In reply please quote: 23/16013

19 April 2024

**SSD-59416728 – PROPOSED DATA CENTRE AT 3 DAVIS ROAD, WETHERILL PARK
(Lot 1 DP 864615)**

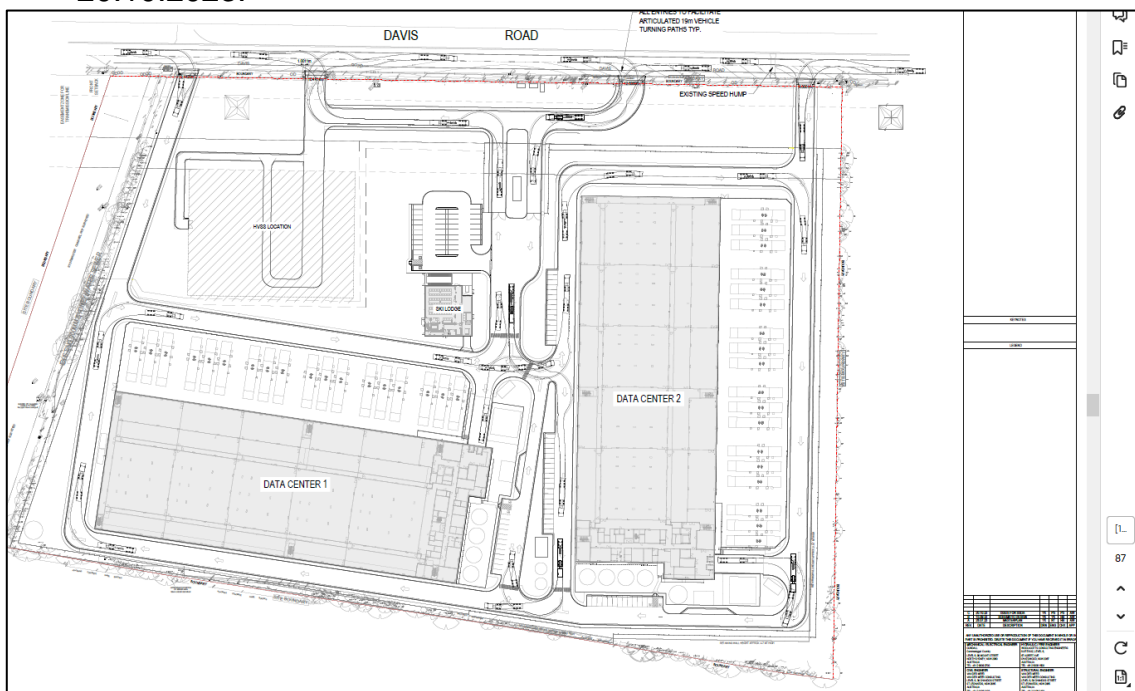
2. The existing property has a single wide driveway divided entry and exit with median. The proposed development has four driveways for a single lot. Note that it will create number of conflicting movements on roads and loss of on-street parking space. The specific need for these driveway access points will need to be adequately addressed by the proponent. Refer to page 39 of EIS Appendix 19 Civil Engineering report, Drawing No. CDL-00-00L-DR-C-2300, Revision C, 20.10.2023:

3. The Vehicle crossings are mostly compliant with Council's Vehicular Crossings policy; however, the main access is not perpendicular in the council road reserve. Council officers recommend that the main access be adjusted to be perpendicular in the road reserve.

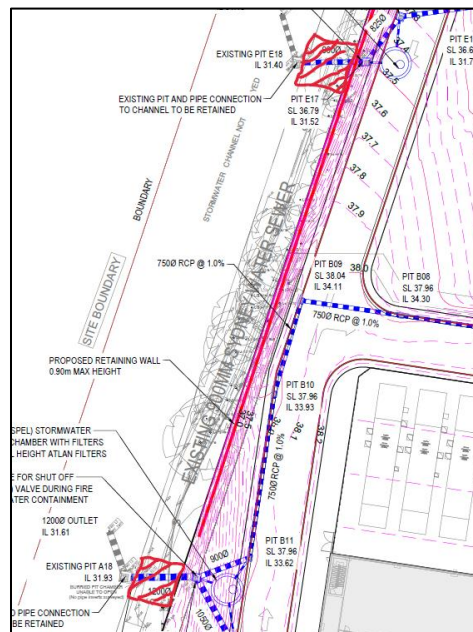
1. Provide a schematic cross-sectional detail of the existing outlets / boundary pits onto the stormwater Channel to enable Council engineers to determine if new works required at outlets.
2. The details of the proposed rainwater tanks shall be clearly shown on the stormwater plan. Provide volume calculation to demonstrate compliance with water conservation requirements as noted in Council's Stormwater Management Policy Sep 2017.
3. Include notation as to how the runoff from the roof drainage will be captured and conveyed to the proposed drainage system.

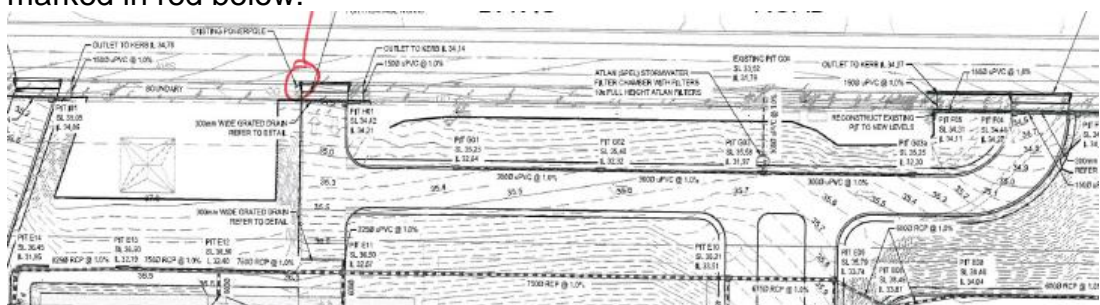
2. Ensure erosion and sediments are controlled during construction to not pollute the stormwater channel.
3. Ensure the Atlan (Spel) Stormwater Filter Chamber is maintained so no pollutants can enter the stormwater system. Stormwater pipes connecting into the culvert or stormwater pit is to be maintained by the owner.
4. Reconstruct the affected concrete lined open channel where it is shown on the map below with the red hatch.
